## Memo

**To:** Cranston City Plan Commission  
**From:** Joshua Berry, AICP - Senior Planner  
**Date:** June 3, 2022  
**Re:** "20 Goddard Drive Warehouse" - Major Land Development - Master Plan

**Owner/App:** 20 Goddard, LLC  
**Location:** 20 Goddard Drive, AP 13, Lot 39  
**Zone:** M-2 (General Industry)  
**FLU:** Government/Institutional

# LANDSCAPE PLAN

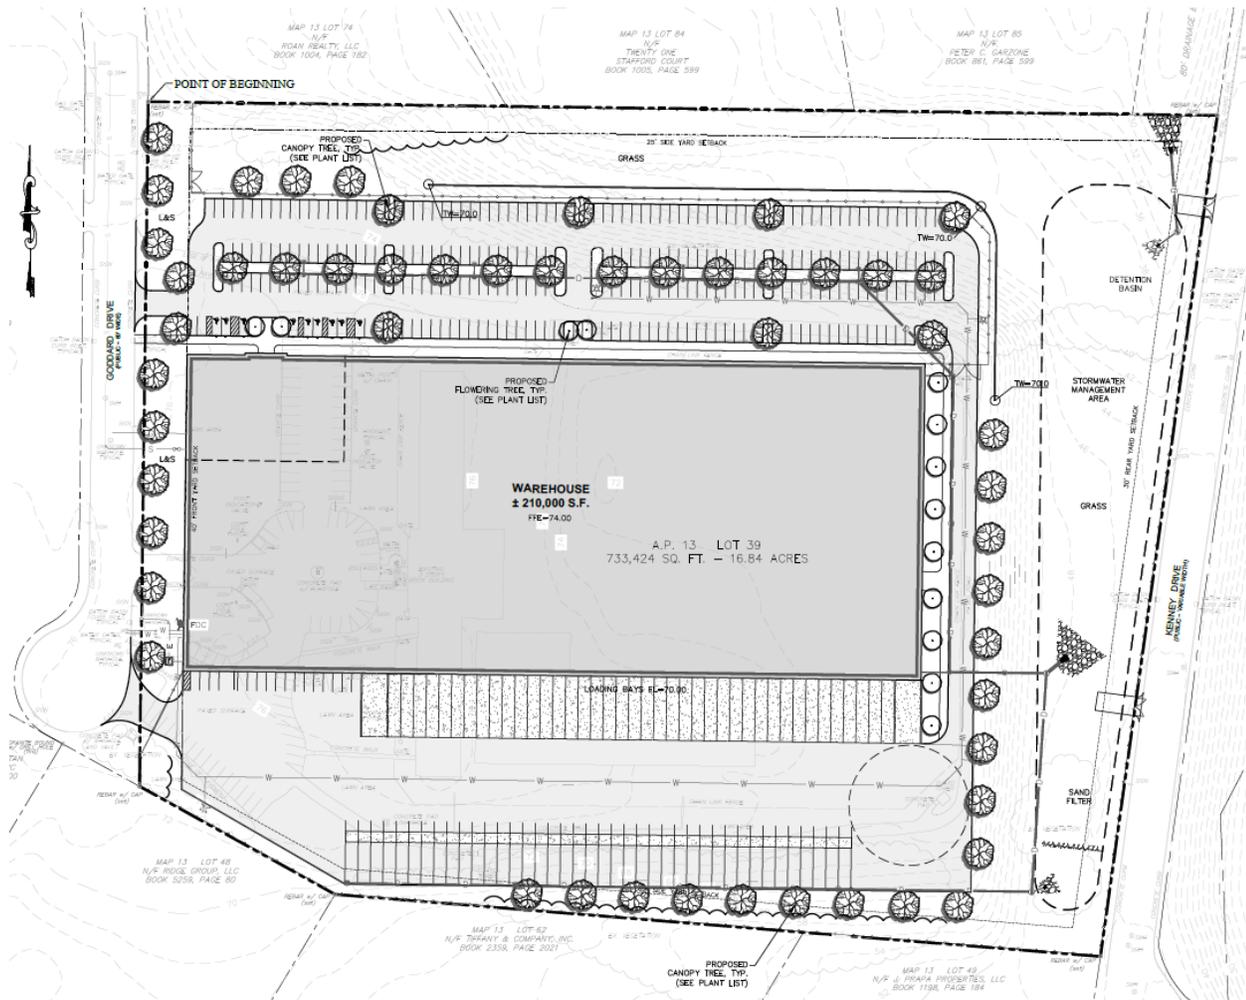
1. The applicant has provided a conceptual landscape plan.
2. A specific calculation was not provided but the site plan indicates that more than 15% of the site is landscaped, meeting or exceeding the city’s requirement.
